Cabinet – 14 October 2021

Written question from Andy Foulkes to the Leader

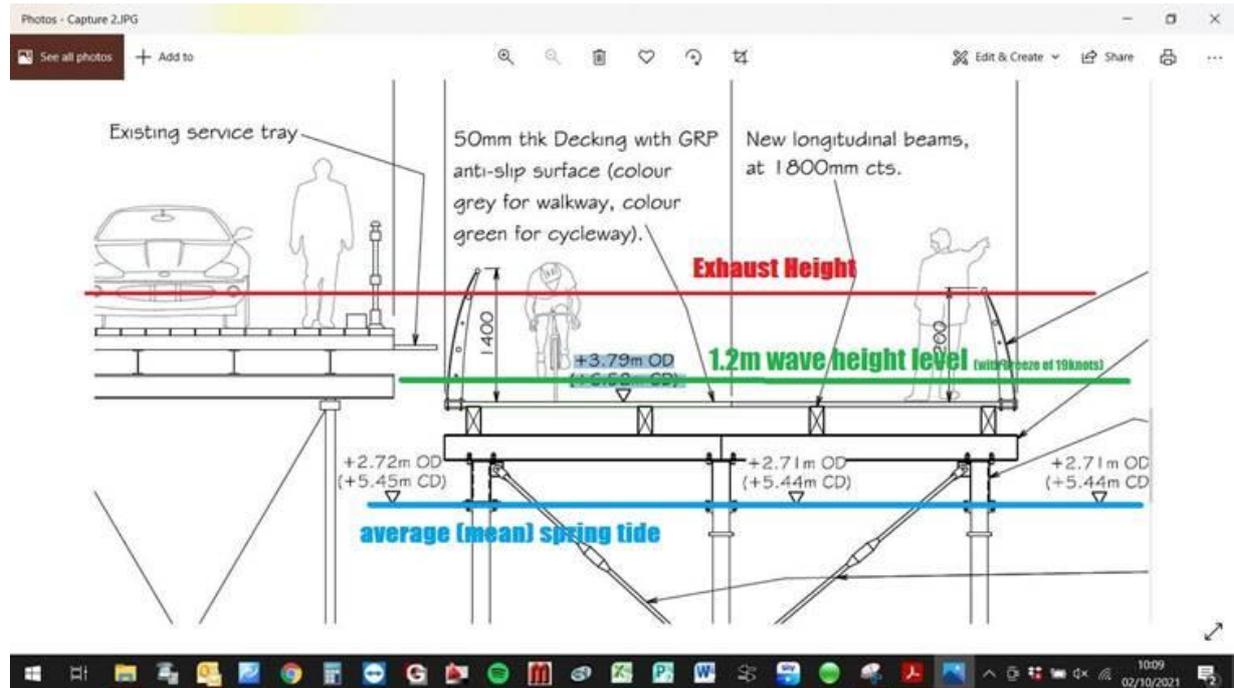
From Andy Foulkes of Island Survey Systems, topographical surveyors, frequently employed by your council property services dept to check and survey Council property since 1992. Here below is the proposed Wightlink ‘cycle/walkway’ that corresponds with your claim to Improve transport for the Island through £10m spend on Ryde Interchange:

1. When my blue, green and red lines are added-you can see this design is a white elephant that could endanger the public?
2. **Are you aware that it is an offense in public duty to knowingly damage the public interest with public money? I have surveyed the proposed cycle and walkway area of Ryde Pier tramway for Wightlink and looked in depth at that planning application which you have granted permission. I can tell you, categorically that.....THIS WALKWAY WILL BE UNSAFE & UNUSABLE more often than usable at high tide:**
 - a) The height of the proposed walk way will put children and disabled users at the exact same height as car exhaust fumes in the prevailing S/W breeze
 - b) and that it will be unusable in a N/E wind, producing a 1m swell at high tide.

Mr Foulkes principle concern is that the reinstated tramway pier will often be swamped by the tide. His sketch shows a mean high water springs (MHWS) level of about +5.45mCD and a notional 1.2m wave crest height at about +6.65mCD. We are not sure where Mr Foulkes has sourced his data as at the current average high tide level at Ryde is only +4.1mCD, MHWS is only +4.5mCD and the highest astronomical tide (HAT) is +5.0mCD which is comfortably below the pier deck level and is consistent with the historic use of the tramway pier.

The level of the pier deck has been established to reflect that of the historic tramway and to secure the setting of the historic pier currently used by pedestrians and vehicles.

A 1.2m notional wave height superimposed onto an HAT tide would result in an average crest height of +5.6mCD rather than the +6.65mCD indicated on Mr Foulkes sketch, (taking into account that wave height is the difference in level between the wave crest and the wave trough) which compares with the minimum deck level adopted of +6.52mCD, increasing in level towards the pierhead and the at the landward end. So the deck will be in the order of 1m above the sea height even in in the most extreme conditions.
